**Addendum:  
WATER QUALITY MONITORING AND ASSESSMENT  
HYDROGEOLOGICAL ASSESSMENT  
Proposed Drainage District #88**

**Report to the Dodge County Circuit Court**

### **Re: Montgomery-Settersten Report on Proposed Dodge County Drainage District 88**

This addendum includes comments regarding the June 29<sup>th</sup> report prepared by Robert Montgomery and Jay Settersten for the Dodge County Drainage Board and petitioners of proposed Drainage District 88 (“Report”).

Figure 1. Gravel Pits at Historic DCAPC Site

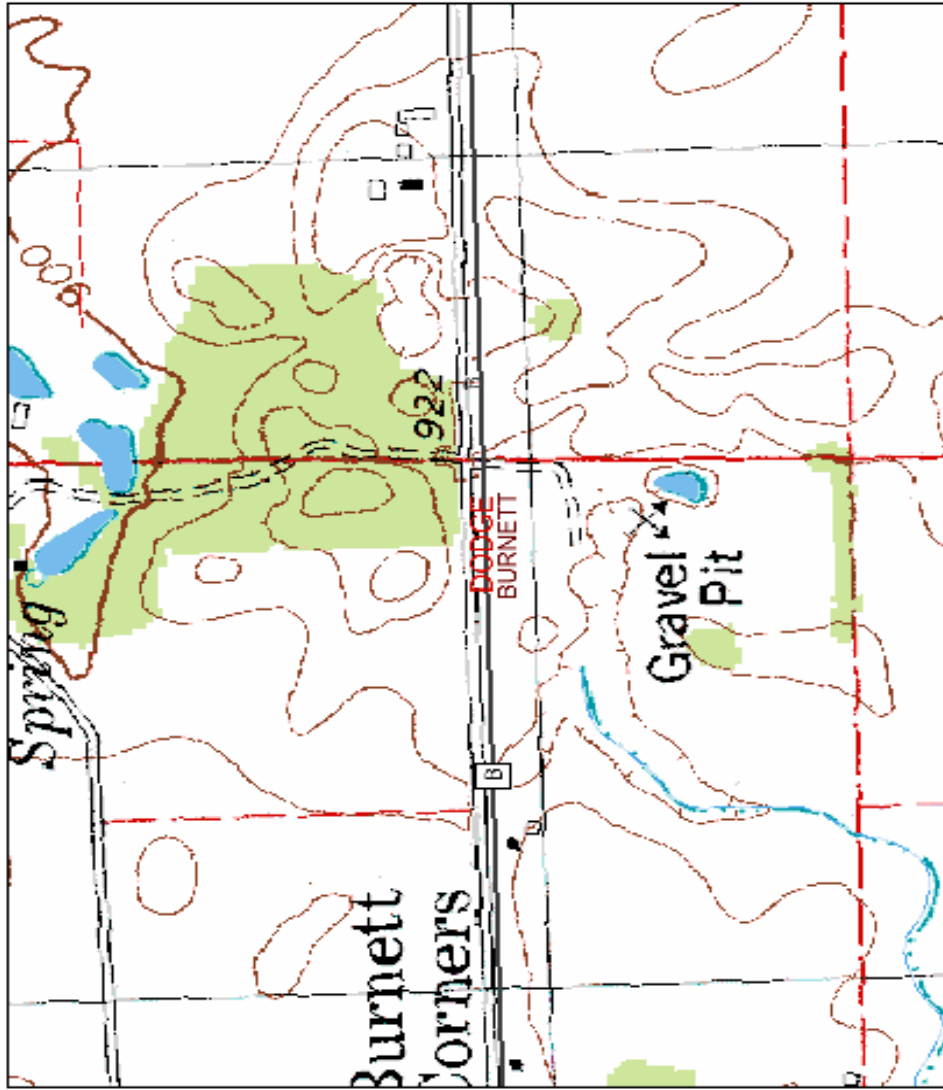
Figure 1 is an archival topographic map of the historic DCAPC site with the gravel pit area clearly identified. The area was about 5 acres in size with two large pits. The map also shows the path of overland flow terminating on site. The authors of the Report appear to have either overlooked this information or not considered its significance.

The Report also concludes that it “... *is unlikely that the club property, including area surrounding the former gravel pits, would have had substantial impact on flood discharge ....*” We believe a more thorough examination of the evidence supports the conclusion that filling and development of DCAPC grounds eliminated the natural retention basin and reduced substantially infiltration of storm water flowing to the site. Significant alteration of the natural hydrologic pattern within lands up-gradient as a result of agricultural production and ditching has caused an increase in runoff to

Figure 3. Method Detection Limit (MDL) and Wisconsin standard for surface waters for phosphorus (as total P). Phosphorus values within the red zone exceeded the state standard of 75  $\mu\text{g/L}$ , while values within the green zone are at or below the state standard.

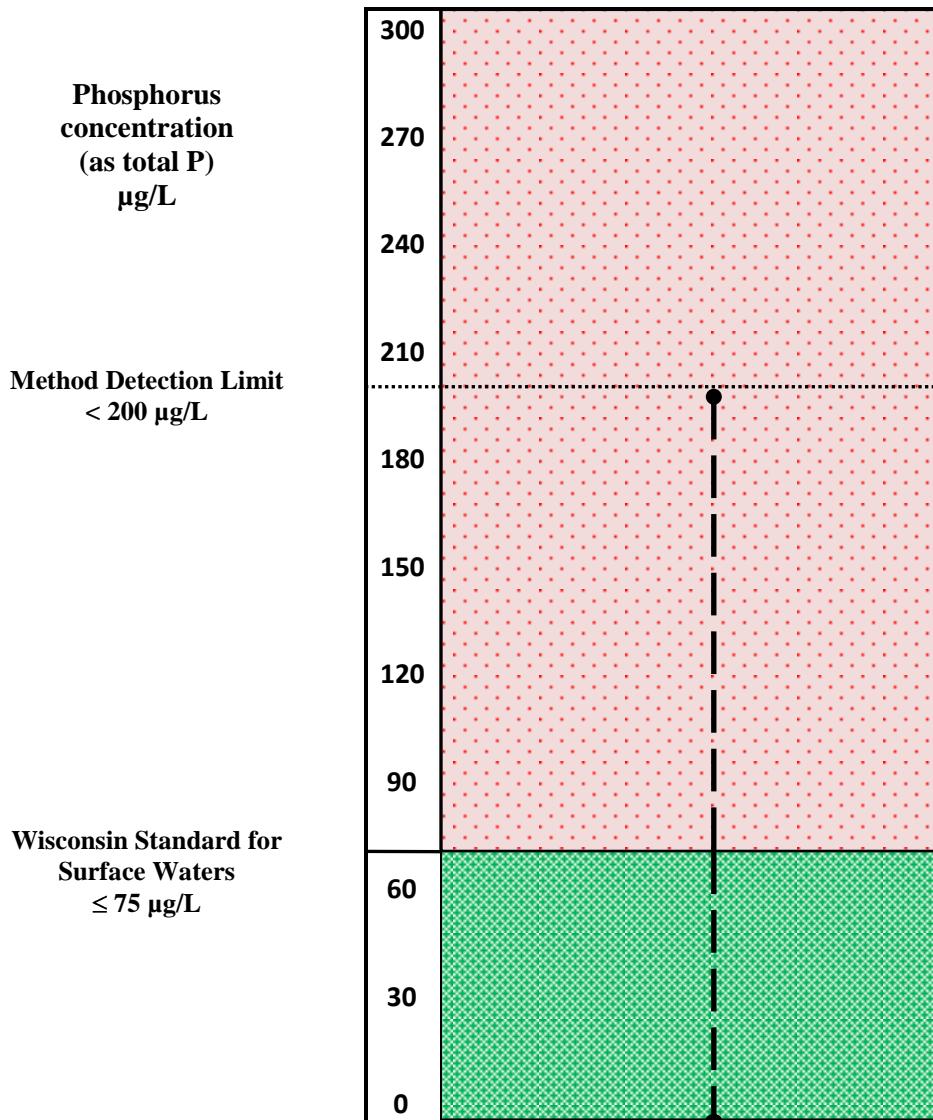
The relevance of MDL in assessing water quality may be demonstrated by Figure 3. Shown on the Y axis with phosphorus concentration in  $\mu\text{g/L}$  are the Method Detection Limit of  $< 200 \mu\text{g/L}$  and the Wisconsin standard for phosphorus in surface water of  $\leq 75 \mu\text{g/L}$ . The vertical dashed line covers the range of phosphorus values that are less than  $200 \mu\text{g/L}$ . Note that the federal definition of MDL with 99 % confidence means that a sample with phosphorus assay as high as  $199 \mu\text{g/L}$  must be reported as  $< 200 \mu\text{g/L}$ .

Figure 4. (below) Phosphorus Concentrations ( $\mu\text{g/L}$ ) at Drainage District 88 Sampling Sites, Spring, Pond, River and Lake

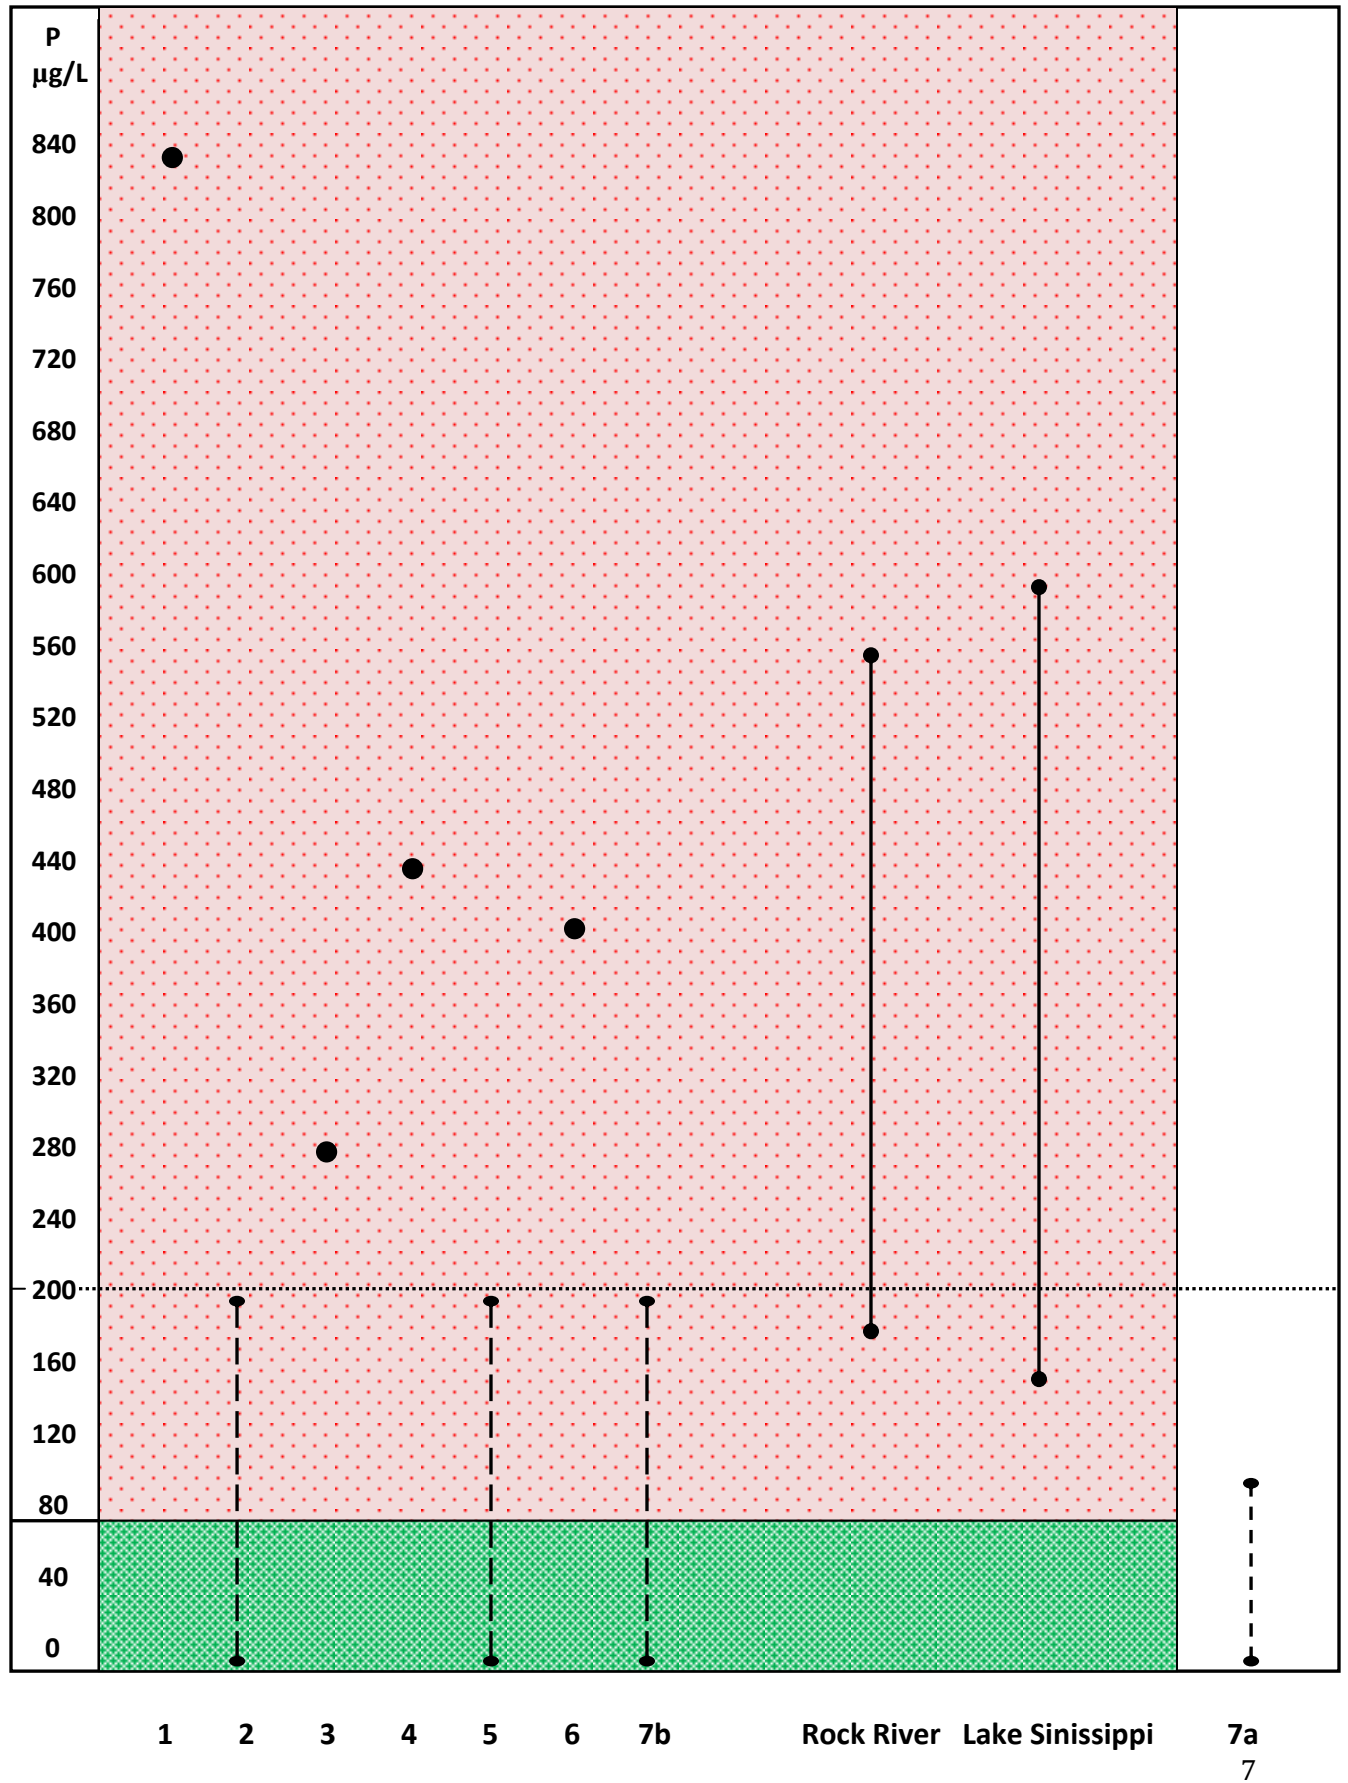
Phosphorus values given in the Lake District water quality report on District 88 are shown in Figure 4, along with the range of phosphorus concentrations in the Rock River and Lake Sinissippi as reported by the US Geological Survey and the Lake District. Sampling site 7a is the spring water (ground water) that flows into the first pond at Spring Brook Farm. The MDL indicates that the value of phosphorus in a sample reported as  $< 200 \mu\text{g/L}$  is likely to exceed the state standard, since the probability of the true value exceeding the state standard (red zone) is greater than the probability of the value being at or below the standard (green zone).

The data clearly demonstrate that there is a phosphorus problem in district drain waters. The sample from Site 1 is in excess of 1,100 % of the state standard. Additionally, the magnitude of the reportable values (*i.e.*, those values greater than the MDL) strongly suggest that the true value of samples reported as being below the MDL would likely fall very close to the MDL, especially since the lowest reportable datum of  $260 \mu\text{g/L}$  is 347 % greater than the state standard.

Figure 5. Total nitrogen concentrations (mg/L) at Drainage District 88 Sampling Sites and Spring Pond.

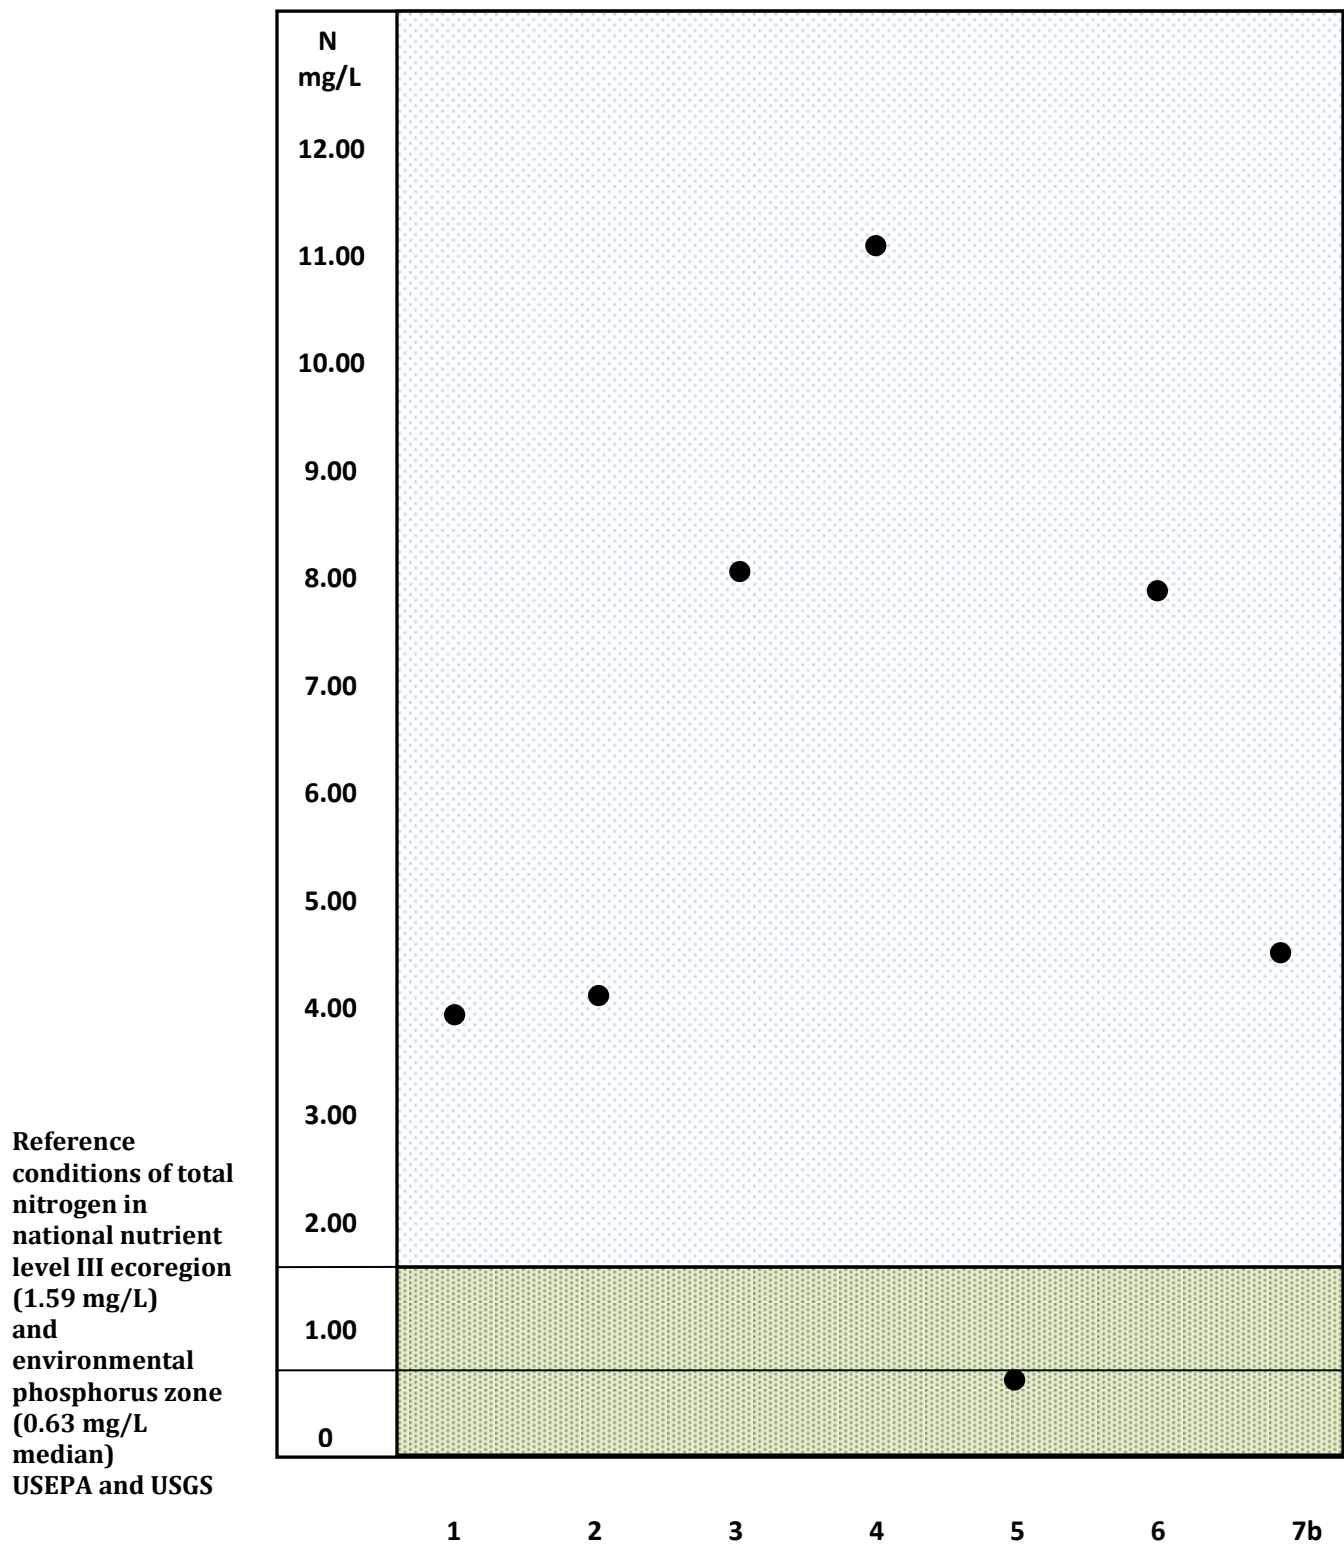
Nitrogen values in samples collected in the proposed district are shown in Figure 5. On the Y axis are values of total nitrogen (total Kjeldahl nitrogen plus nitrate and nitrite nitrogen) in mg/L at each sampling site. Also shown are the reference concentrations for total nitrogen in national level III ecoregion 53 (1.59 mg/L) and environmental phosphorus zone 2 (0.63 mg/L) (Sources: US Environmental Protection Agency 2000 and Robertson, D M *et al*, 2006). Nitrogen values in drain water of the proposed district dramatically exceed federal reference conditions. The sample from Site 4 is 700 % of the reference value. (Given the high nitrogen values in the other samples, the low value at site 5 is probably an anomaly; however, there was an insufficient volume of water available for a re-test.)
